Job ID: 2012-10-5119-ALTR

Project description: <u>18'x22' ATTACHED ADDITION (IN BACKYARD) 24'x24' ATTACHED (2) CAR GARAGE W/ INCORPORATED MUDROOM. PROVIDE A VAULTED CEILING IN MASTER BEDROOM. DEMO & REBUILD DECK</u>		
Contractor's name: <u>MAINE CONTRACTORS GROUP</u>		Email: <u>celine@mainecontractorsgroup.com</u>
Address: <u>20 HILLTOP LANE</u>		Telephone: <u>653-4189</u>
City, State & Zip: <u>LITCHFIELD, ME. 04350</u>		Telephone: <u>653-7700</u>
Who should we contact when the permit is ready: <u>LANCE BAKER</u>		Telephone: <u>653-7700</u>
Mailing address: <u>SAME AS ABOVE</u>

Jonathan Rioux - Re: 6 Goveside

From: Celine Gagnon <celine@mainecontractorsgroup.com>
To: Jonathan Rioux <JRIOUX@portlandmaine.gov>
Date: 10/19/2012 2:27 PM
Subject: Re: 6 Goveside

6 GROVESIDE RD,
18' x 22' ADDITION
CHANGES TO ROOF SYSTEM

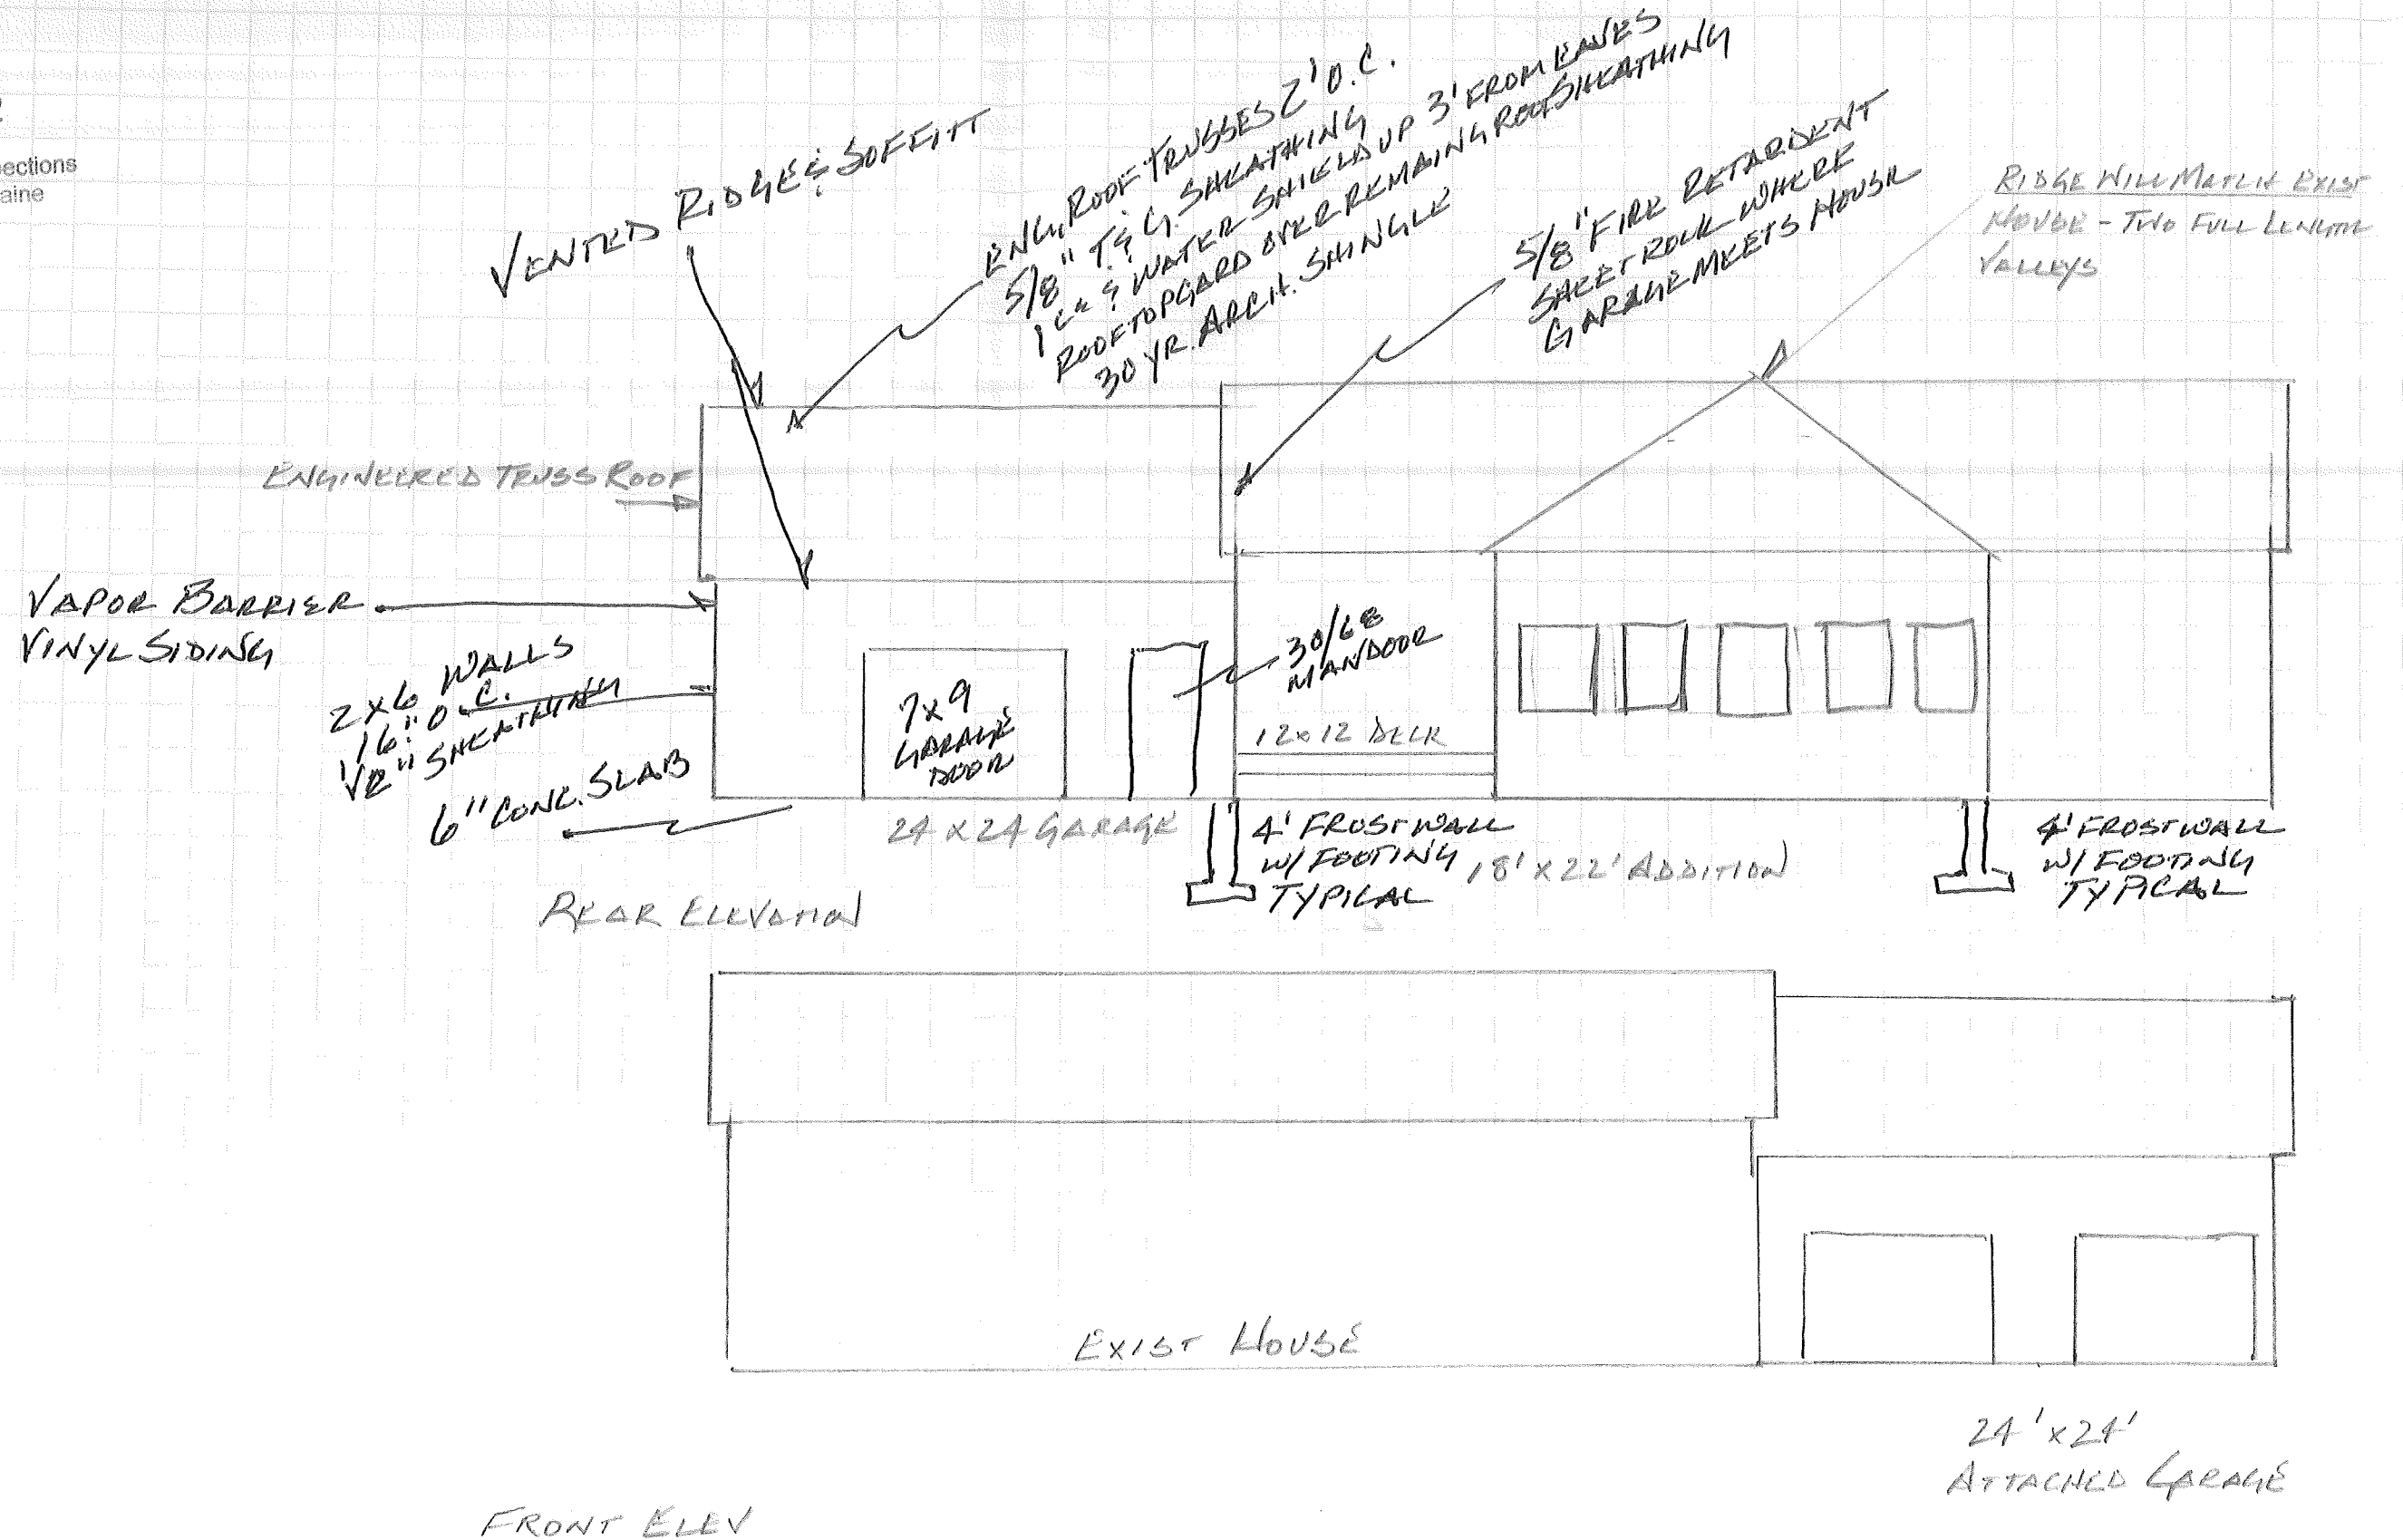
What are the beam spans/ sizing between each "Sona Tube"?

8'

2" X 12" X 22" K.D. SPRUCE JOISTS
@ 12" O.C. TYP. JOISTS REST ON
8" CONCRETE FROSTWALL & PLATE AT
OUTBOARD END AND IN JOIST HANGERS
AND LEDGER ON INBOARD END.

1 3/4" X 12" X 16' LVL

6" X 6" X 4' FT POST TYP. @ EITHER END,
KNOTCHED TO ACCOMMODATE LVL +/- 12" IN GROUND

2x10" RAFTERS - 2' O.C.
TYPICAL

(2) 1 3/4" x 16" LVL'S

2x6" COLLAR TIES - 2' O.C. TYPICAL

MAP # 102
LOT # C5
SCALE 1/4" = 1'

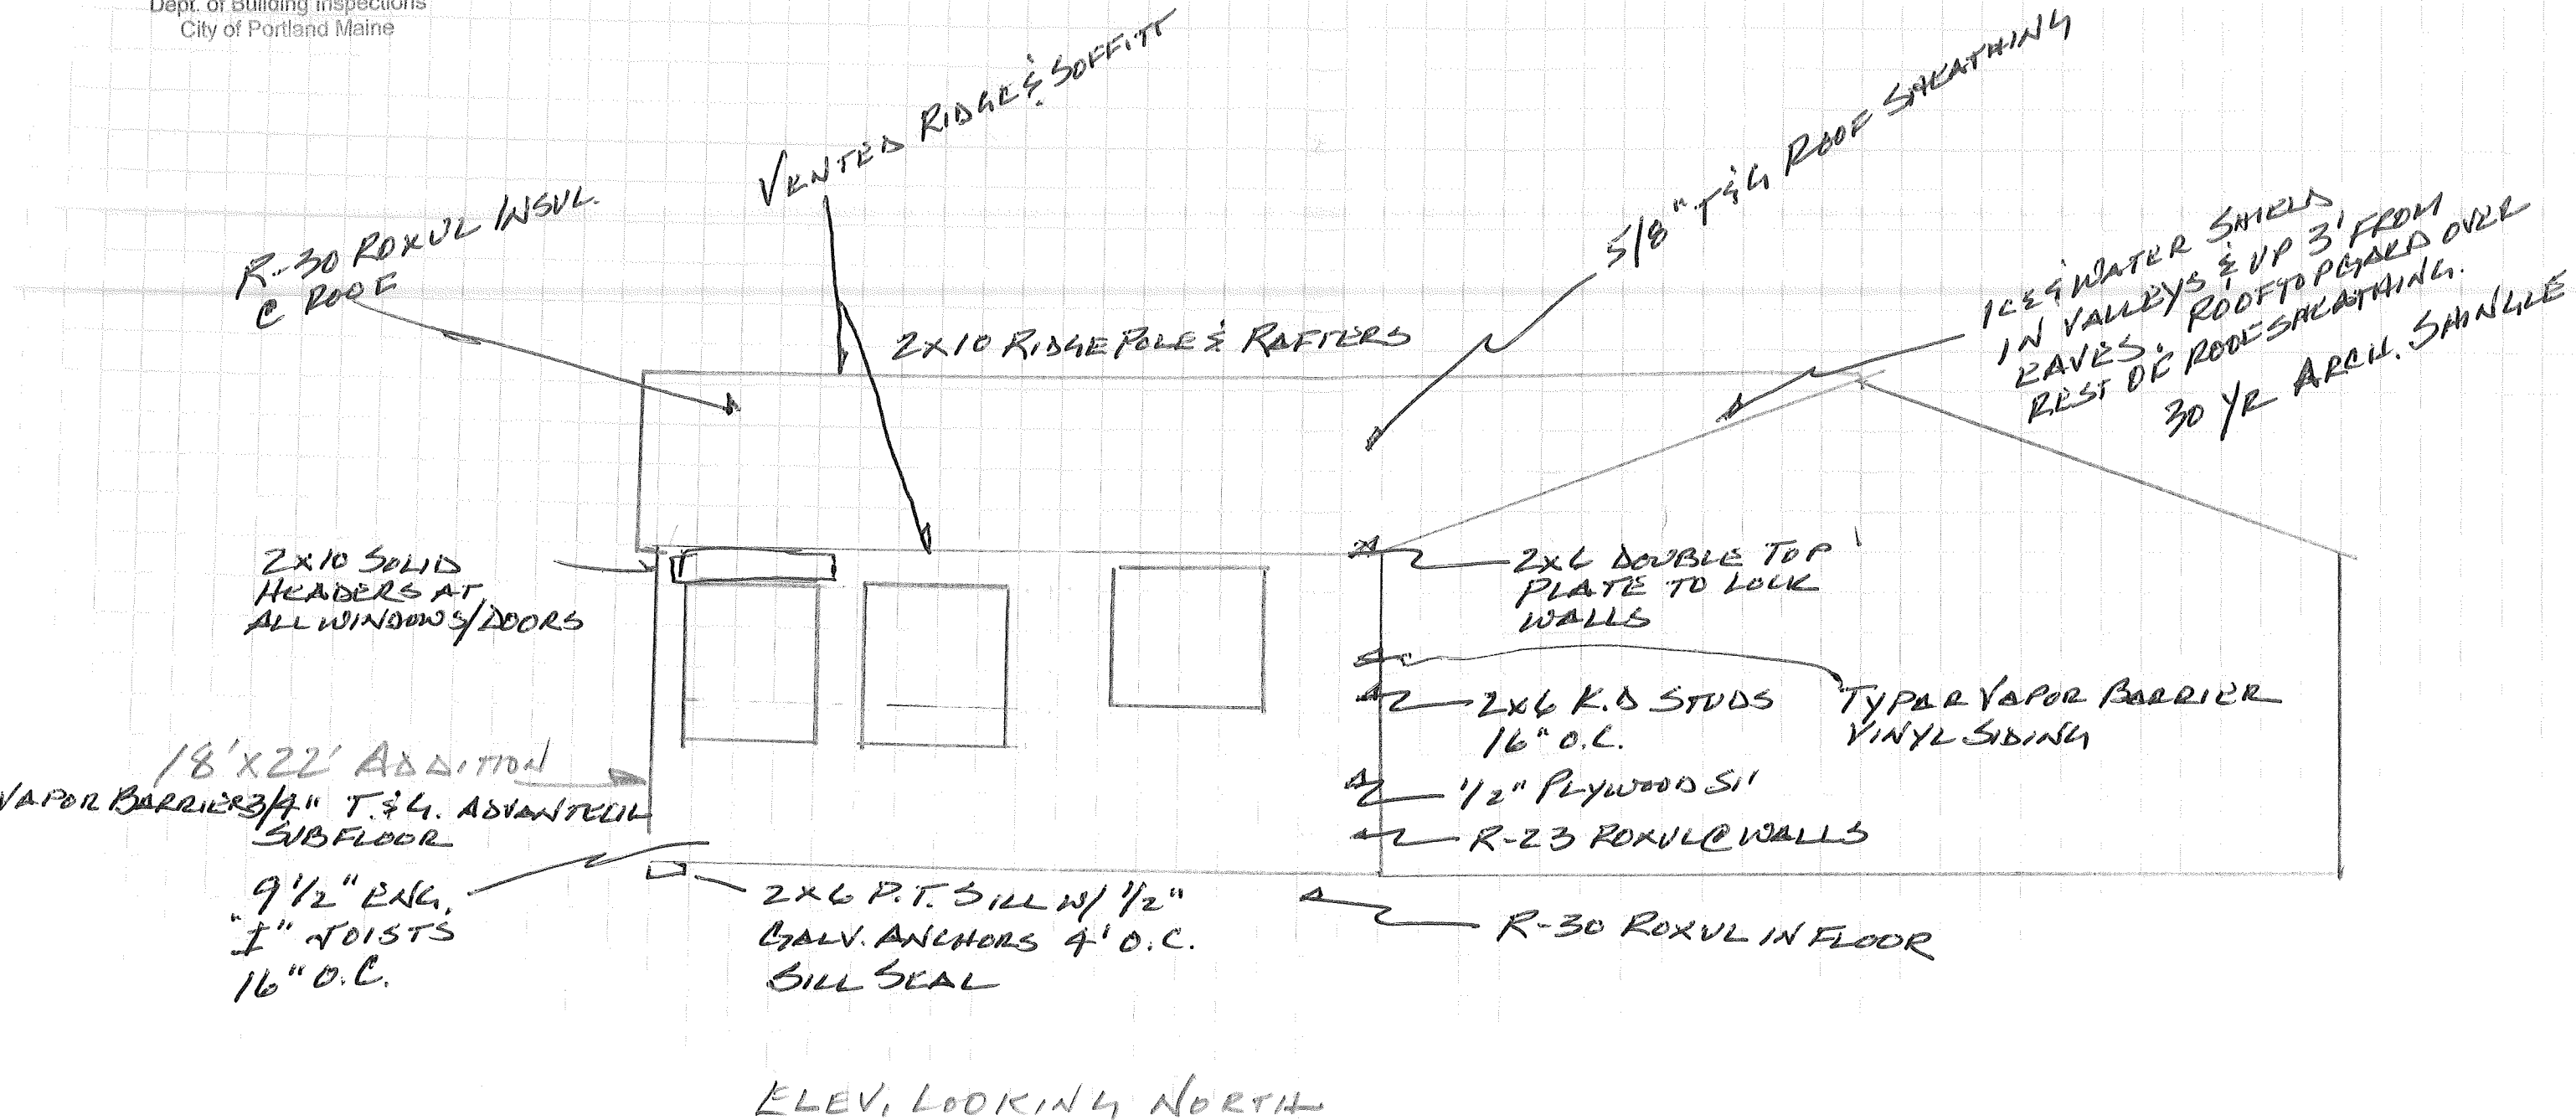
12-3-12 DWM Tyler close-in provide radotr ties, plumbing incomplete.

ⓑ Revised floor framing plan, ⓓ Ledger bolting.

#5 REBAR
EPOXY ANCHORED
TO EXIST. FDN

4' T x 8" W COAL. FROSTWALL

12" x 8" FOOTING

MAP # 182
LOT # C5
SCALE: 1" = 10'

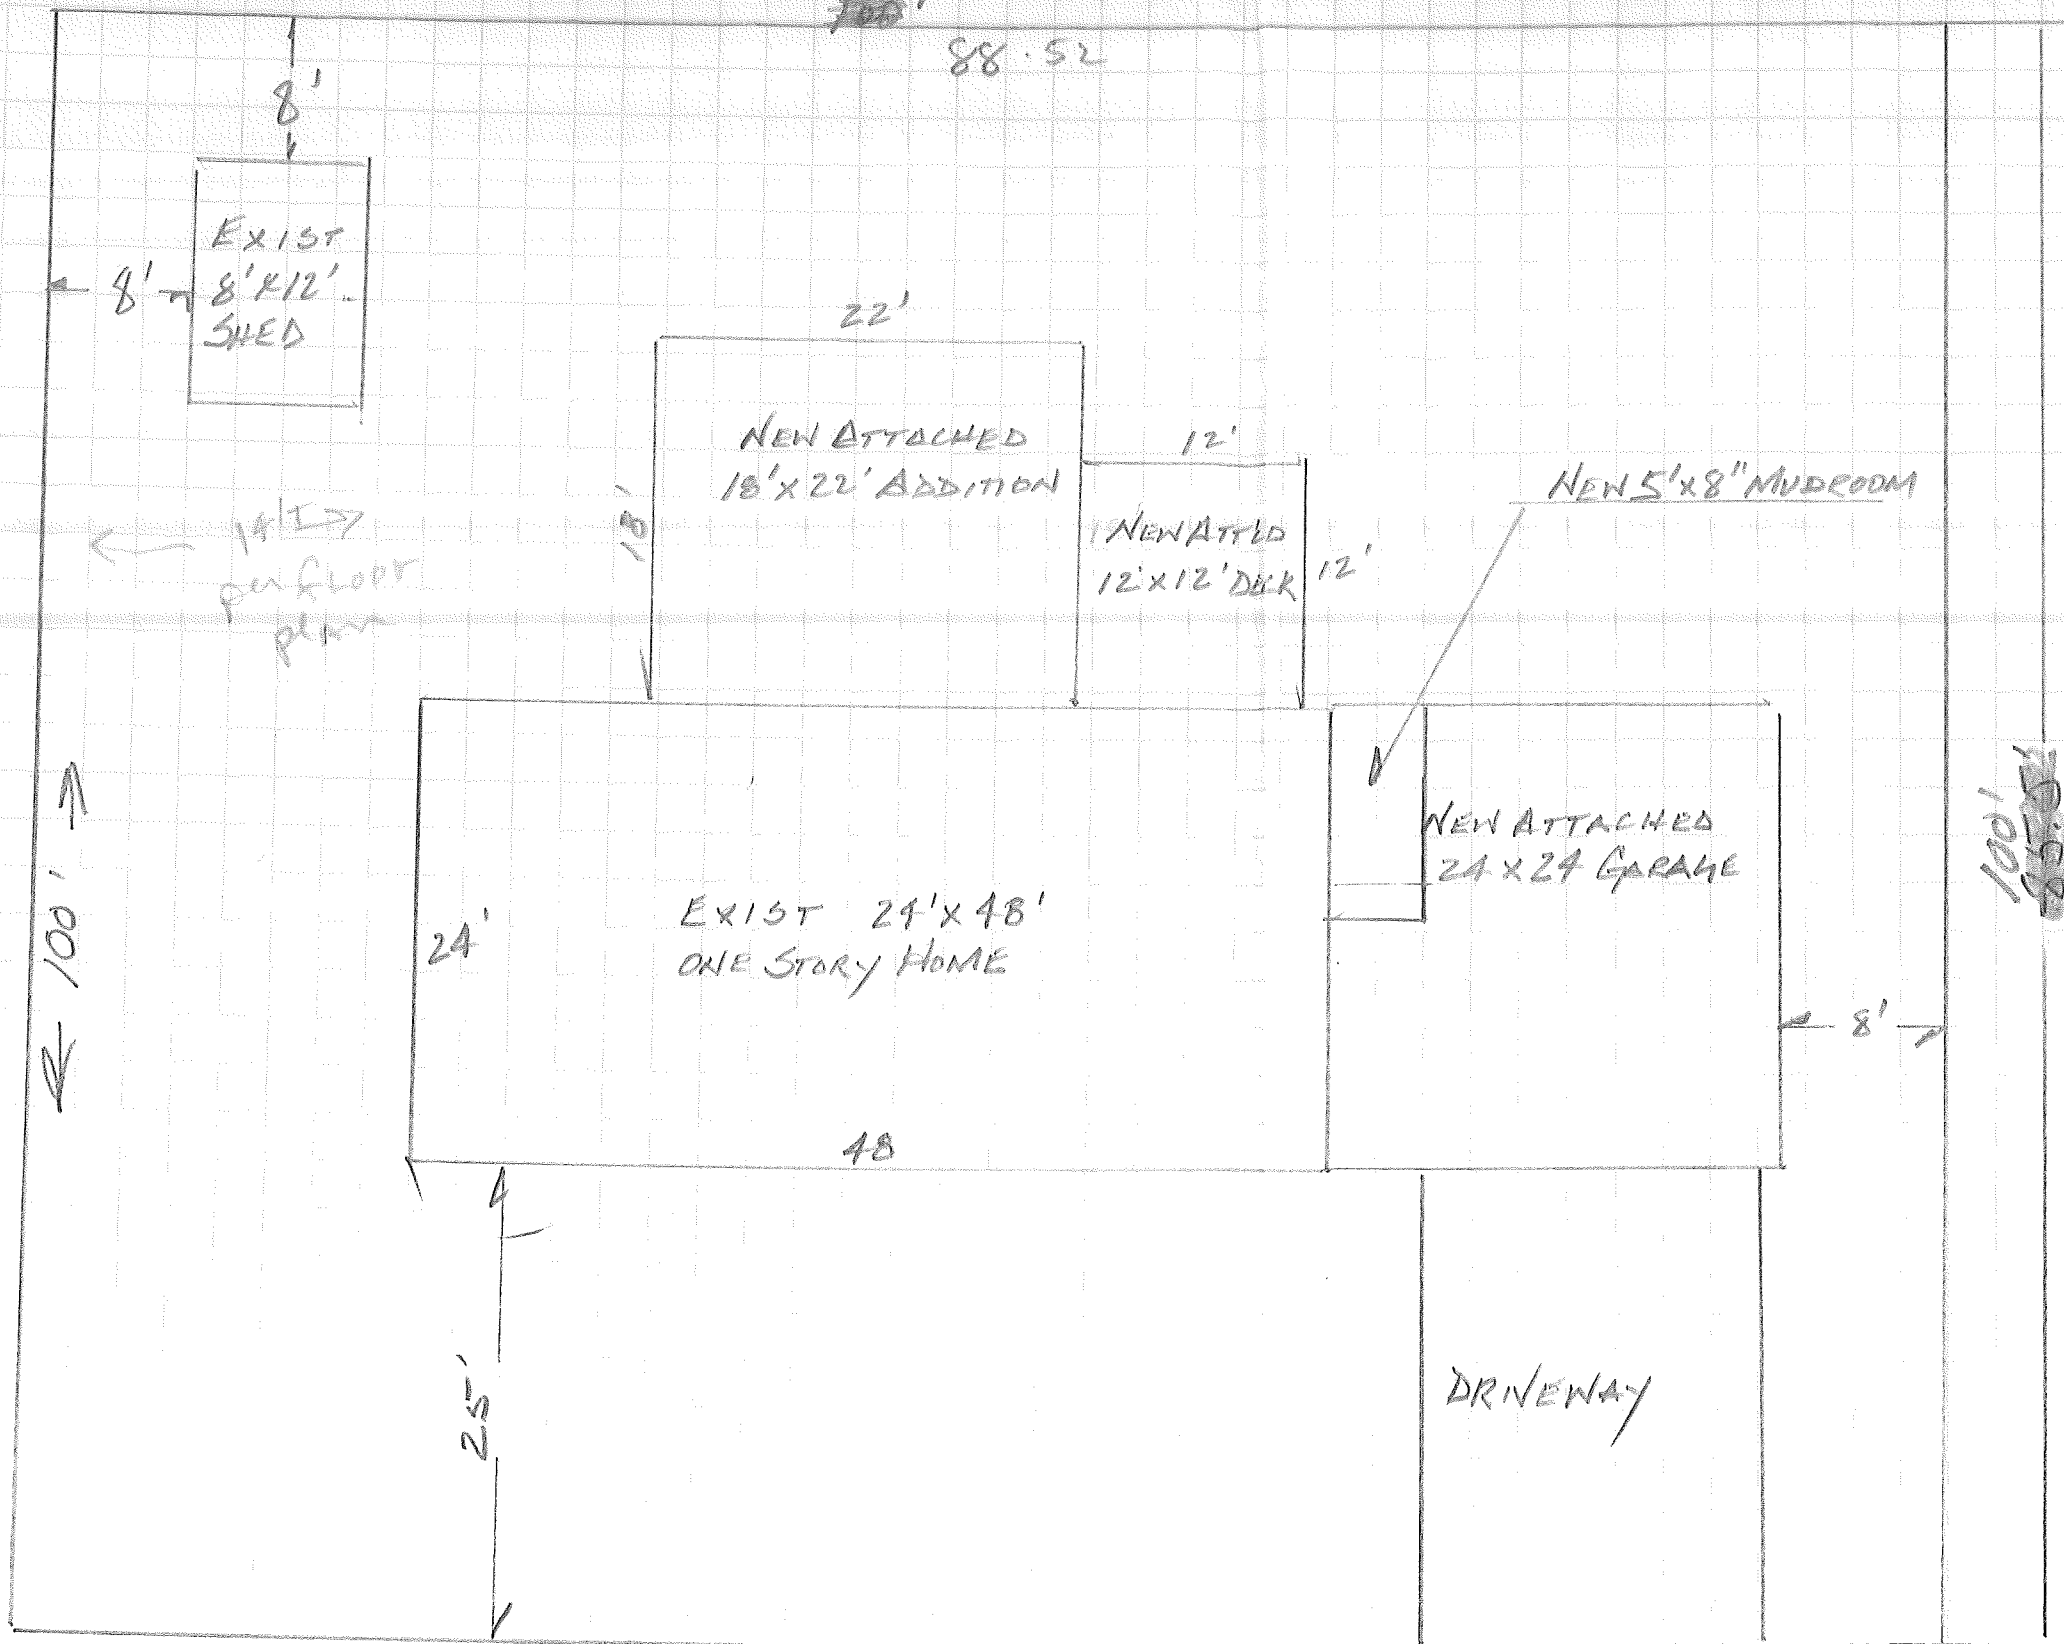
100
- 67
33'
↓
should be
the REAR
set back
per information

Front: 25' min req - 25' show
Rear: 25' min req - 33' assumed by plan
Side: 1st story 8' min 8' & 14'+ show
